Determination 2010/014

Safety barriers surrounding a swimming pool area at 60A Goldflats Lane, Coatesville, Rodney

Figure 1: Area 1

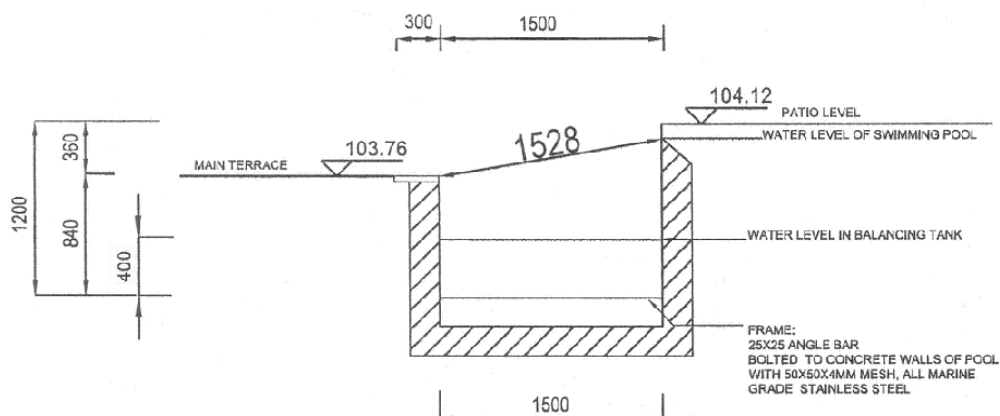
3.2 Area 1 uses the balancing tank for the overflowing weir as a pool safety barrier to the full length of the southeast end of the pool. The tank has an internal width of 1500mm and has a maximum water depth of 400mm above a grate situated above the base of the tank. The wall between the tank and the swimming pool is 200mm thick, and has a top 1200mm above the steel grate of the tank that is splayed towards the pool. The diagonal distance between the front edge of the tank and the wet edge of the pool is 1543mm.

As the balancing tank has a maximum water depth of 400mm and is not defined as being used for swimming, wading, paddling, or bathing it is not required to be fenced. The top of the tiled wall of the swimming pool is 1200mm above the grate of the tank, and the diagonal distance of more than 1200mm between the front edge of the balancing tank and the wet edge of the pool comply. Accordingly, the tank meets with the requirements of Clause F4 and the FOSP Act.

- 6.2 The balancing tank that protects the southeast end of the pool has a maximum water depth of 400mm and therefore under section 5(b) of the FOSP Act, the tank is exempt from the requirements of the FOSP Act. The limits on application of Clause F4 mean that Clause F4.3.3 of the Building Code does not apply to the tank as it is a 'pool exempted under section 5' of the FOSP Act.

- 6.3 The exterior face of the swimming pool wall adjoining the tank has a smooth tiled face that is 1200mm above the grate of the tank. Clause 1(1)(a) of the Schedule requires 'the fence shall extend at least 1.2 metres above the ground on the outside of the fence'. This pool wall provides a 1200mm barrier to the swimming pool in accordance with clause 1(1)(a) of the Schedule.

- 6.4 The tank is 1500mm wide and has a diagonal distance of 1543mm from the front of the edge of the tank to the wet edge of the pool. Clause 1(1)(b) of the Schedule requires 'the fence shall extend at least 1.2 metres above any permanent projection from or object placed on the ground outside and within 1.2 metres of the fence.' The width of the tank and the terrace edge of the tank is greater than the 1200mm minimum set out in clause 1(1)(b) of the Schedule.

- 6.7 As the Schedule is a means of establishing compliance with the Clause F4, I therefore consider the pool wall and tank in Area 1 complies with the requirements of Clause F4 as a pool barrier. However, I note the risk locations shown in Figure 5 must be designed and constructed so that there are no projections or ledges in these areas.

Figure 2: Area 2

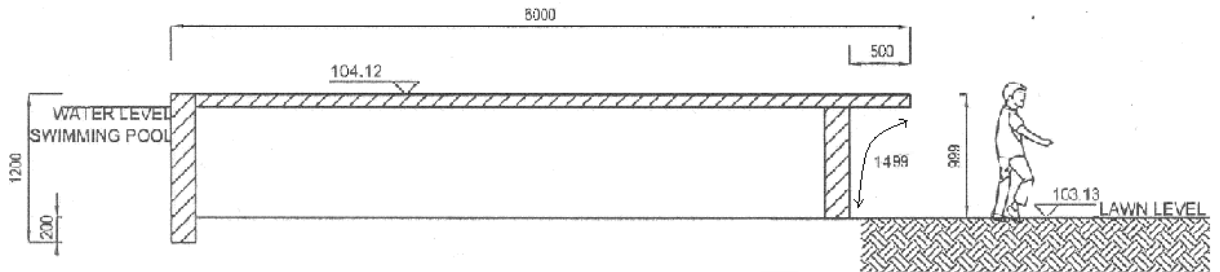
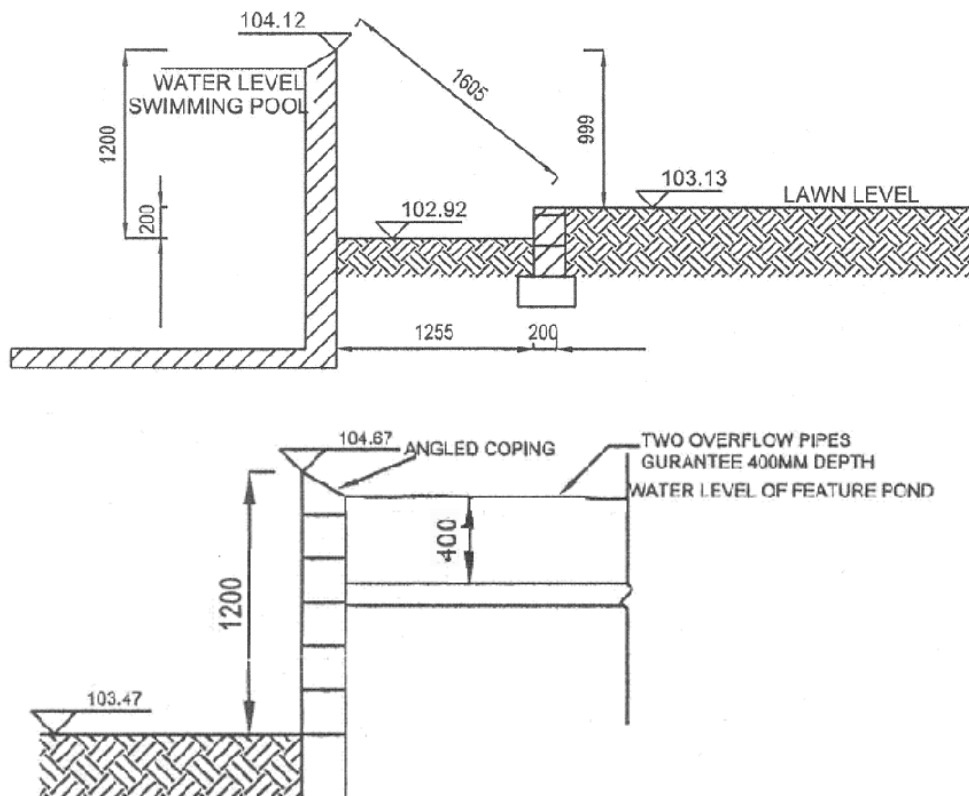
- 3.3 Area 2 comprises a raised terrace 8000mm long x 7500mm wide that adjoins one edge of the pool or the pool surround. The perimeter of the slab is 999mm high above the finished ground level and the slab has a 500mm wide cantilever overhanging the perimeter walls. As described by the landscape architect, this configuration gives a combined clear distance of 1499mm. No barrier protection is provided to the perimeter of the terrace.

A child younger than 6 years of age would not be able to stand on the lower lawn, hold onto the slab overhang and swing up onto the terrace because there are no toeholds anywhere. The addition of the overhang and the 999mm of relevant wall height make up a total safety distance of 1499mm. As the terrace itself is 999mm above the natural ground level, it does not require a barrier to prevent falling.

- 6.8 The terrace that protects part of the pool has walls that, including the thickness of the terrace slab, are 999mm high above the finished ground level. The slab itself overhangs the wall for a distance of 500mm as shown in Figure 2.

- 6.11 A solid 1000mm high barrier would probably be somewhat easier for children to climb than the 'standard' swimming pool barrier 1200mm high given in the Schedule. This type of fence can have a horizontal rail providing a foot hold near the bottom. The horizontal extension provided by the terrace overhang is therefore needed to provide additional climbing difficulty. The question to be answered is

whether the 500mm slab extension is sufficient to prevent children gaining a grip with their shoes on the vertical surface underneath the extension. In my view, it is sufficient because the extension places a child in a position such that they cannot put any force on their foot against the vertical surface to provide any grip in the vertical direction. Additionally, the edge of the extension does not provide an easy grip, compared with, for example, a 30mm diameter rail. A child old enough to have the strength to pull themselves directly up and onto the platform extension would also have no difficulty climbing the standard fence of the Schedule.

- 6.12 Accordingly, I consider that the perimeter wall to the raised terrace together with its associated 500mm overhang projection is an alternative solution to the Clause F4.3.4 (f) requirement to restrict the access of children to swimming pools.
- 6.13 I also accept that as the top surface of the slab is less than 1000mm above the finished ground level, it does not require barriers in terms of Clause 4.3.1 of the Building Code.
- 6.14 Therefore I consider the terrace in Area 2 complies with the requirements of Clause F4 as a pool barrier.

Figure 5: the detail to the edge of the balancing tank

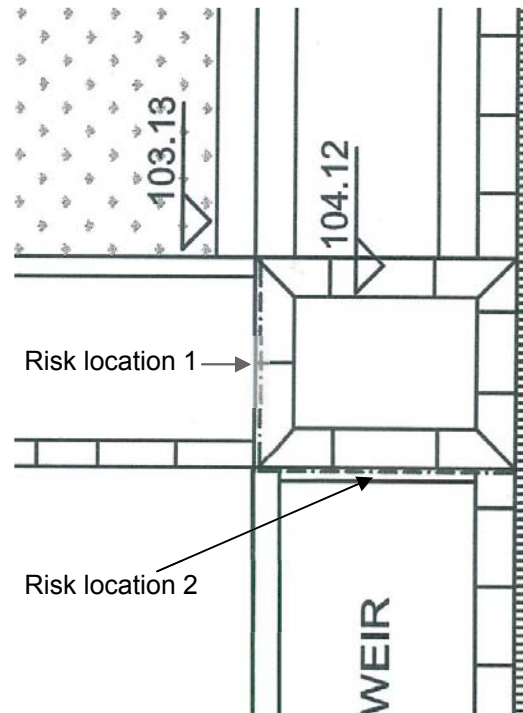
- 6.5 It is my view that there are risk locations at the edge of, and adjacent to, the balancing tank. The risk locations, both of which are beside the 1200mm glass pool barrier are shown in Figure 5.

- 6.6 Both locations must be designed and constructed so that there are no projections or ledges that provide footholds, where children under the age of six may be able to straddle the end of the fence and shuffle along, gripping on the top of the barrier.

- how the areas adjacent to the balancing tank will be designed and constructed with no projections or ledges that could provide toeholds that could allow children under the age of six to enter the pool area unsupervised
- how the area adjacent to the feature pond where there is only a 650mm difference in levels will be detailed to prevent children under the age of six from entering the pool area unsupervised.

Figure 6: Unfenced area beside the feature pond

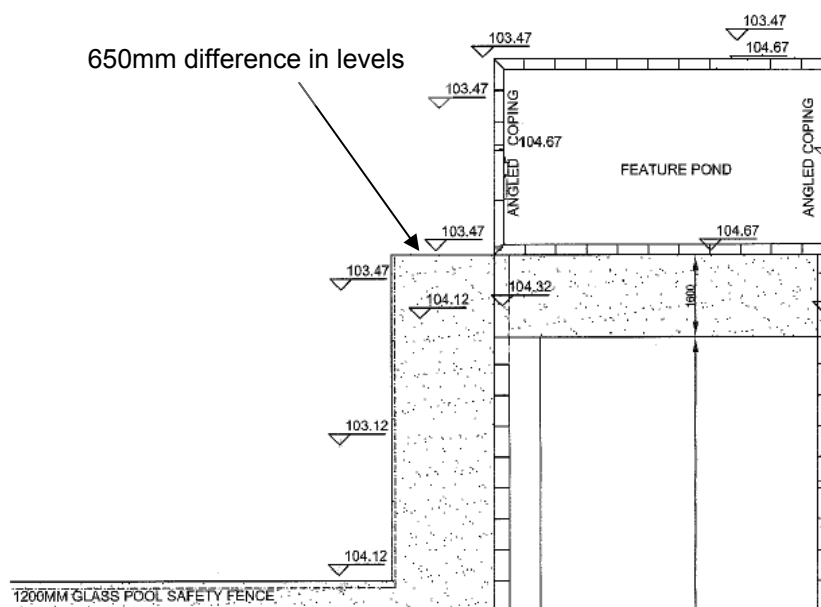
- there has not been an application for an amendment to the approved building consent and the applicant has applied for a determination without the authority having made a decision on the proposed barriers
- the authority was never in dispute of the details shown in figures 1, 3, and 4 (refer to paragraph 3.2 and 3.4) and having reviewed the detail, the authority now accepts that the details shown in figure 2 (refer to paragraph 3.3) complies with Clause F4
- at the opposite side of the terrace and feature pond to Area 2, the level of the terrace is 104.12, and the adjacent ground is 103.47, representing a difference in height of 650mm, hence the glass barrier should be extended to the feature pool.

- 6.15 The water feature that protects the northwest end of the pool has a maximum water depth of 400mm, like the balancing tank. Therefore, the water feature is exempt under section 5(b) from the requirements of the FOSP Act and therefore Clause F4.3.3 of the Building Code does not apply to the water feature.
- 6.16 The feature has external walls that are plastered and are 1200mm high above the finished ground level. The feature therefore provides a 1200mm barrier to the swimming pool in accordance with clause 1(1)(a) of the Schedule.
- 6.17 I have noted the authority's comments about the area at the opposite side of the terrace and feature pond to Area 2 (refer to paragraph 4.5). There is a difference in levels between the ground and terrace area of only 650mm as shown in Figure 6, which according to the plans is unfenced.

6.18 I consider the detail for the water feature in Area 3 complies with Clause F4 as a pool barrier. However, the area adjacent to the feature pond, represented by the unfenced 650mm difference in levels (shown in Figure 6) is not in accordance with Clause F4.
